TAN002 - Tracker One v1.0 Shipping Mode

Shipping mode issue impacting Tracker One v1.0 devices manufactured before August 31, 2020.

Published: May 4, 2021

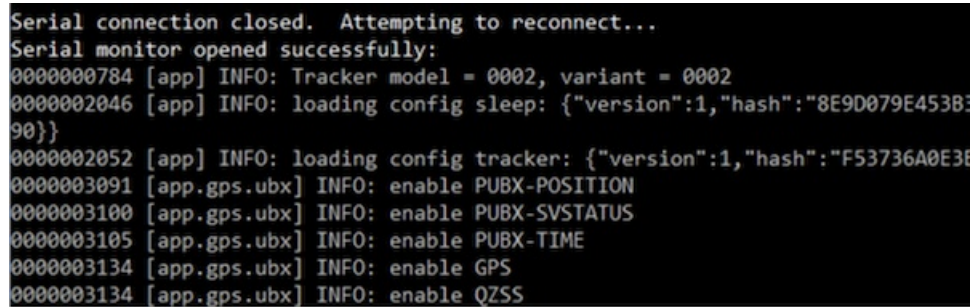
If there is leakage current on the GPIO, Serial, or I2C pins to the Nordic MCU at the time when shipping mode is entered, the MCU can enter an unusual state where it cannot be woken from shipping mode by applying power to the USB or M8 connector as documented. If this occurs, the only way to wake the device is to fully disconnect the Li-Po battery, which requires opening the sealed Tracker One enclosure.

If you are using the M8 connector, the easiest mitigation is to disconnect the M8 connector to your peripheral device before entering shipping mode. You can reconnect it after safely in sleeping mode if desired, or leave it disconnected during shipping.

This issue has been corrected in a subsequent revision of Tracker One (v1.1), expected in October 2020.
